MPC Paper No. Y/H3/6A For Consideration by the Metro Planning Committee on 17.4.2015

<u>APPLICATION FOR AMENDMENT OF PLAN</u> UNDER SECTION 12A OF THE TOWN PLANNING ORDINANCE

APPLICATION NO. Y/H3/6

1-7 Tak Sing Lane, Sai Ying Pun, Hong Kong

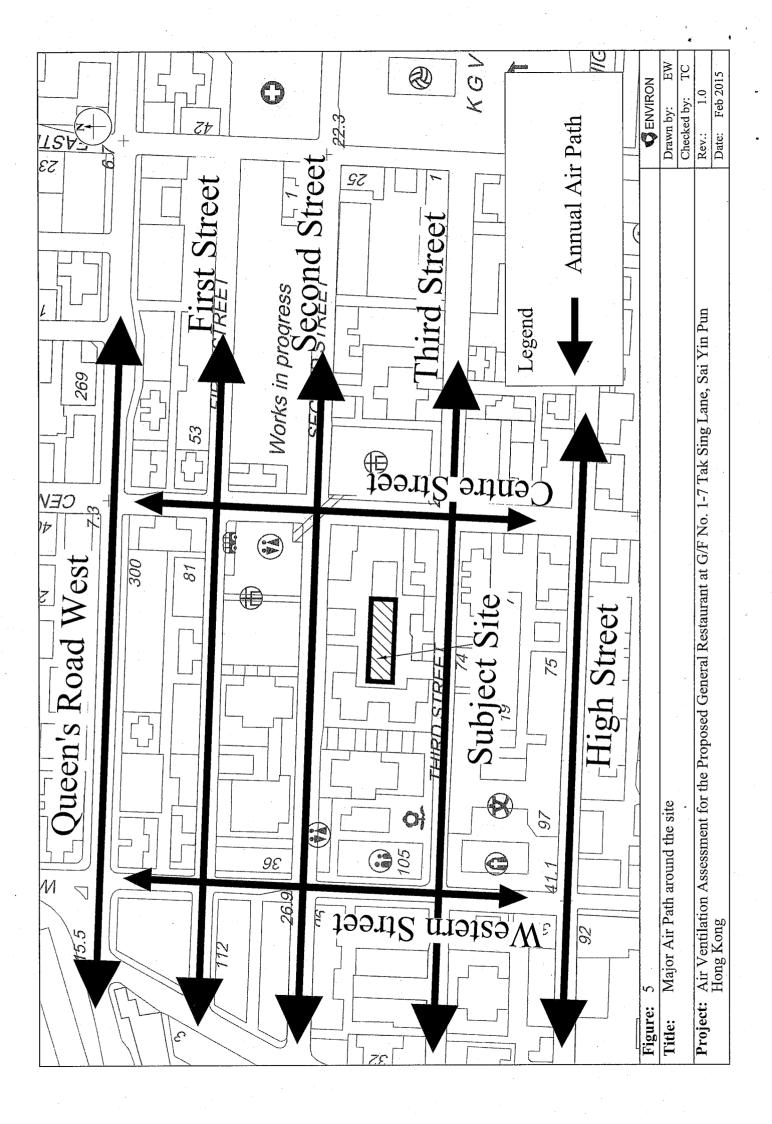
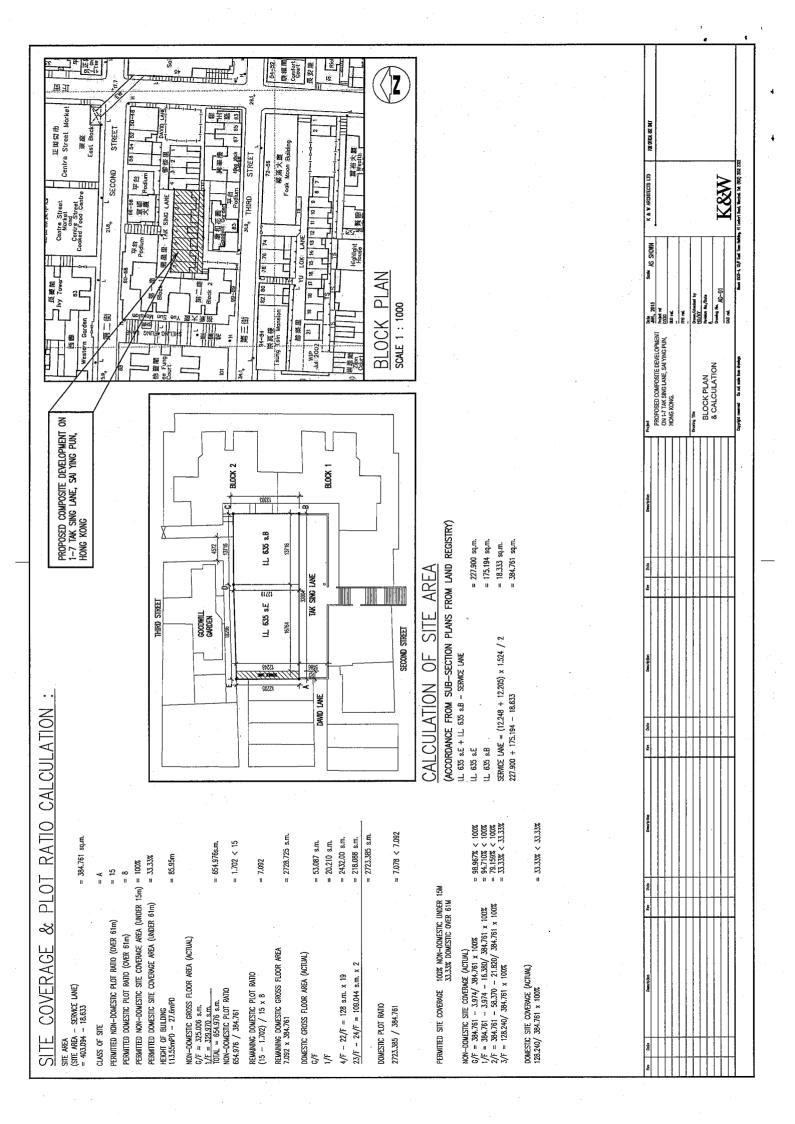
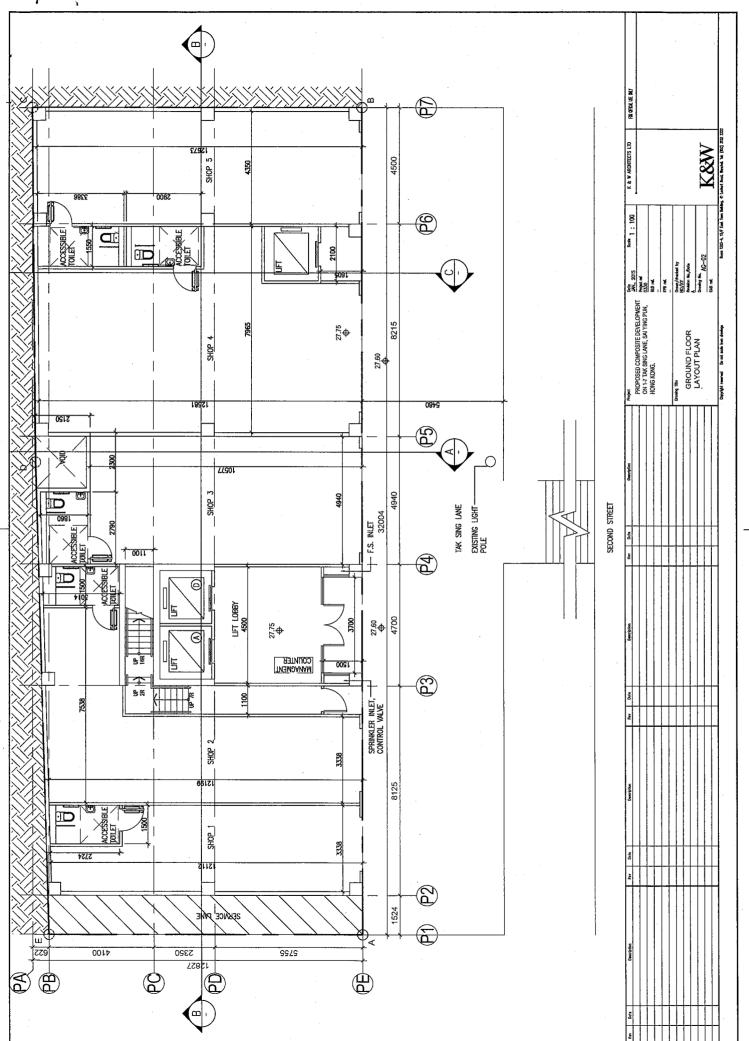
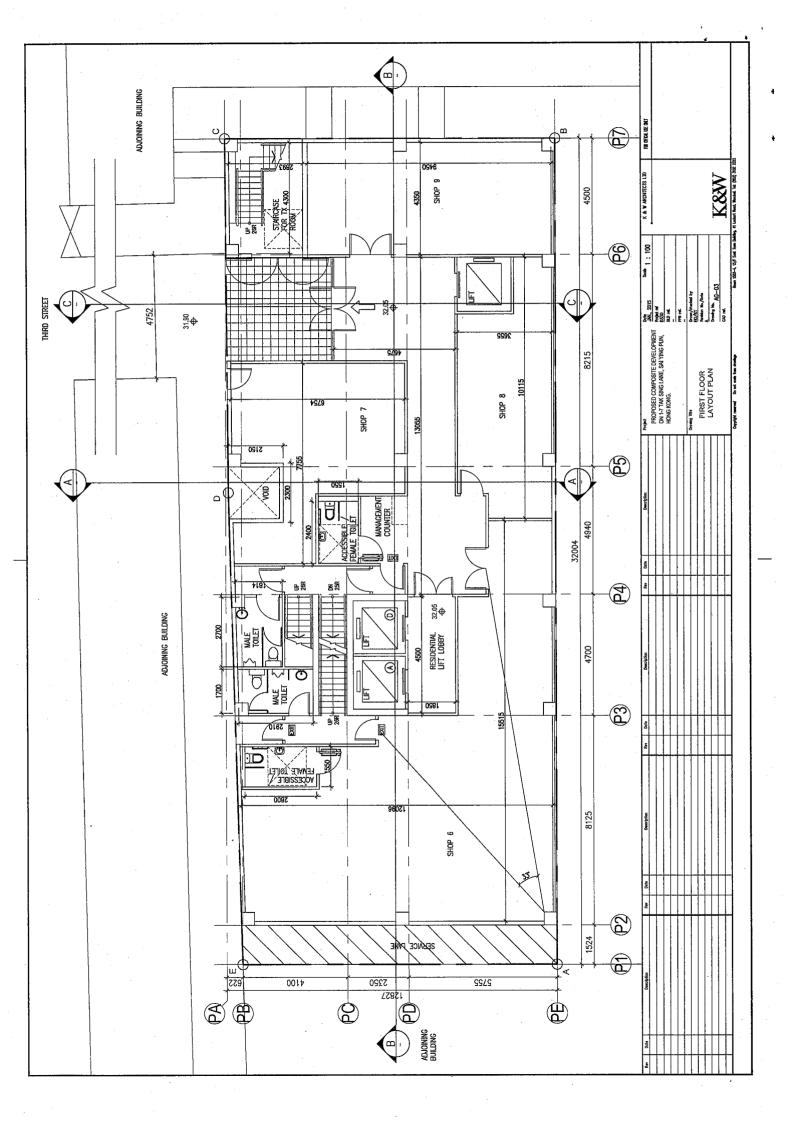
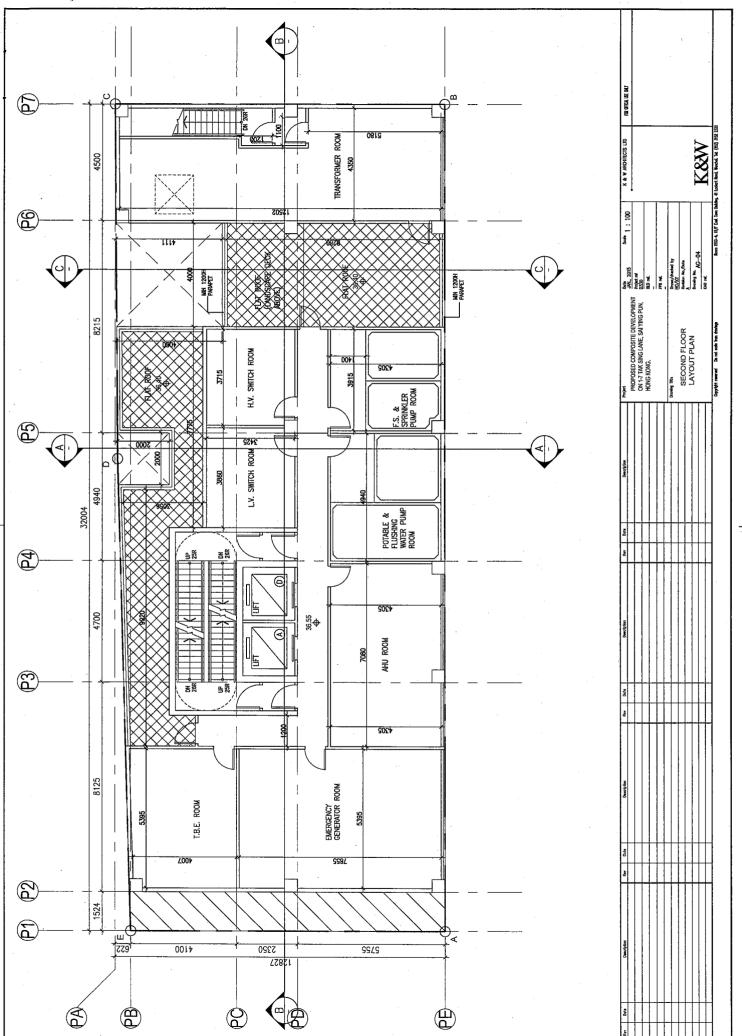
#### (g) Figure 2 (wind rose) -

- (i) The applicant should clarify whether "Figure 2" should read "Figure 3"; and
- (ii) The figure caption does not tally with the current application.

#### (h) Figure 4 -

- (i) The applicant should provide the building names and street names for easier reference to the text; and
- (ii) The figure caption does not tally with the current application.
- (i) Figure 5 The figure caption does not tally with the current application.
